Docket Item #24
DEVELOPMENT SPECIAL USE PERMIT
#2005-0009
Alexandria Toyota Parking Garage

Planning Commission Meeting
June 7, 2005

DSUP #2005-0009

Parking Structure Proposed
by the Applicant

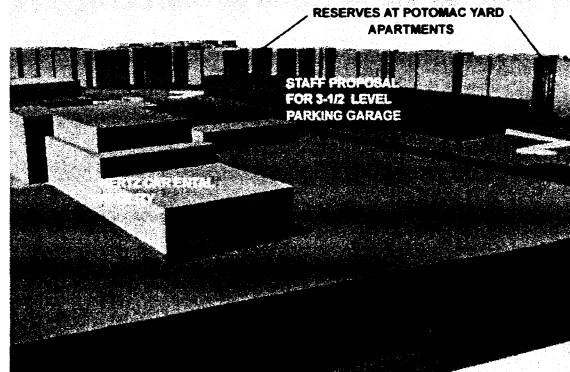
The Lynhaven Civic Association has expressed concern about the mass and scale of the proposed parking garage structure in their neighborhood. The neighborhood residents believe that the proposed parking structure would negatively impact their neighborhood and is contrary to the goal of obtaining higher quality redevelopment in areas such as East Reed. The owners of the adjoining apartments have also expressed their opposition to the garage because of the negative impacts on residents whose units will now face a 5½ story parking structure.

While the changes proposed by the applicant are positive and begin to help mitigate the visual impact of the large parking structure, staff does not believe these measures alone adequately address the impacts of the proposed parking garage. Therefore, staff is recommending as a condition of approval that the height of the structure be lowered by two stories, and that additional architectural treatment and landscaping be provided.

Parking Structure Proposed
by Staff

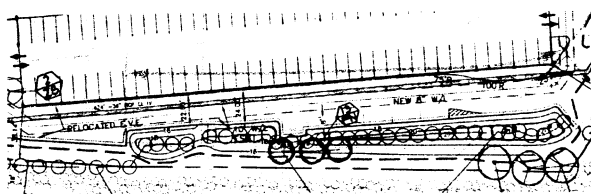
Although the applicant did not make any of the major changes to the garage proposed by staff, the applicant has provided modifications to the plan which will help to soften the visual impact of the garage:

1. The applicant flipped the footprint of the garage so that the 4 ½ story portion of the structure rather than the 5½ story portion fo the structure is adjacent to the residential units
2. The applicant provided a red stucco finish with punched window treatment.
3. The applicant widened the landscape strip between the residential buildings and the garage, providing a slight berm and additional opportunities for landscaping; and, the applicant also agreed to provide additional landscaping along Four Mile Run to buffer the view of the garage from the north.

While the changes made by the applicant are all positive, staff does not believe they go far enough to mitigate the visual impact of the mass and scale of the proposed parking garage. Therefore, staff is recommending that two levels of the garage be removed to reduce the overall height of the parking garage, reducing the height from 48 feet to a maximum of 32' or from 5 ½ levels down to 3-3 ½ levels. This reduction in height would significantly reduce the visual impact of the garage on the apartments and reduce the visual massing from adjacent public areas. Reducing the garage by two levels will eliminate 231-304 parking spaces from the garage (average of 116-152 spaces per level), resulting in a total of 419-492 parking spaces in the garage.

Applicant's Proposed Landscaping

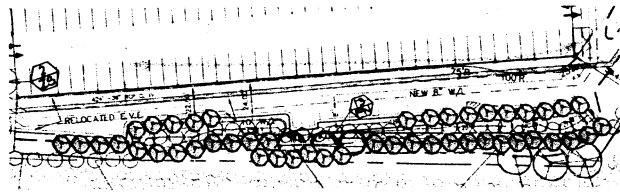
Staff had recommended that the applicant provide an increased buffer area with berming along the property line adjacent to the apartments as another means of buffering the apartment use from the proposed parking garage. The applicant removed and/or relocated approximately 45 to 50 parking spaces to provide a buffer area varying between 12 and 25 feet deep. Although the berming was not as substantial as recommended by staff and measures only about five feet tall, it does provide somewhat of a modest psychological and physical separation between the two sites. The applicant has proposed a row of Austrian Pines atop the berm. Staff is recommending that a variety of additional evergreen trees be planted within the buffer strip and that the minimum height of the trees upon installation be at least 14 feet tall so that there is immediate screening of the garage's lower levels.

Recommended Additional Landscaping

Exterior Appearance

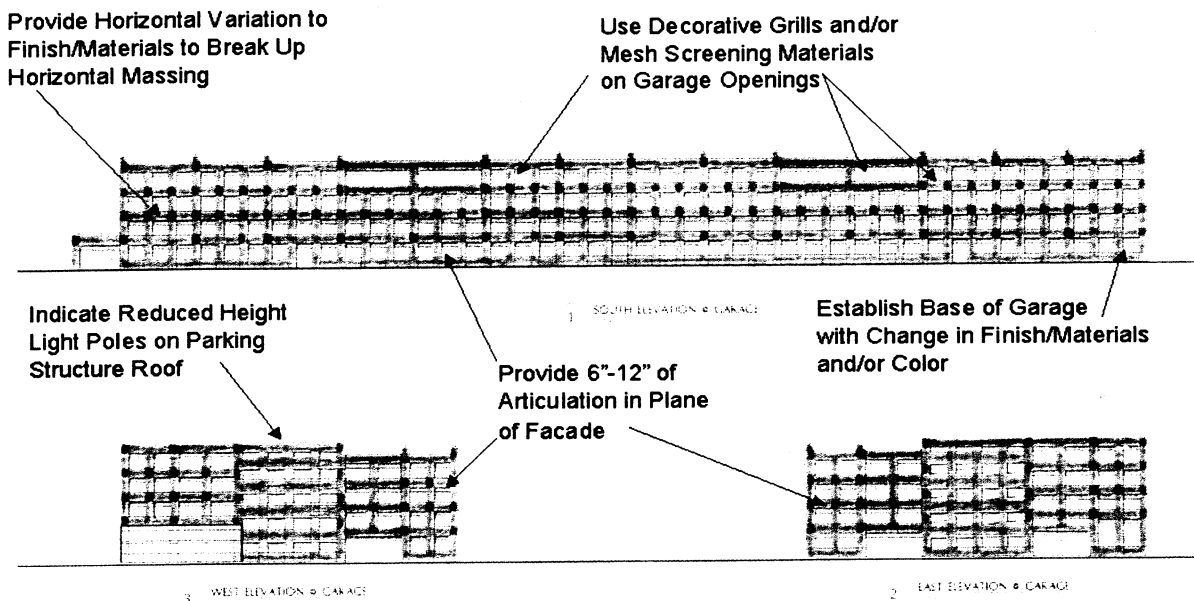
The appearance or exterior design treatment of the parking garage is critical to minimizing the visual impact of the garage. Typically, garages are constructed of poured in place concrete or are prefabricated concrete. They traditionally are a gray color with long spandrel openings between the decks and are very unattractive, particularly when they are sited in urban settings. Staff recommended that the parking garage would have to have an enhanced design appearance utilizing traditional building colors consisting of such colors as brick red, buff colored precast concrete and other earth tone colors. In addition, staff recommended that the garage openings be reduced in size consistent with punched window openings. The applicant did respond by providing exterior design treatment that complied with these recommendations. However, the design of the garage needs attentional attention to resolve issues of mass, scale and exterior building materials. Staff is recommending a number of design guideline requirements to further refine the exterior design treatment of the parking garage. It is staff's goal to have the parking garage appear more as a building than a parking structure. Several of the recommendations are focused on breaking up the building's massing so that bays and horizontal elements appear more as the scale of a traditional building.
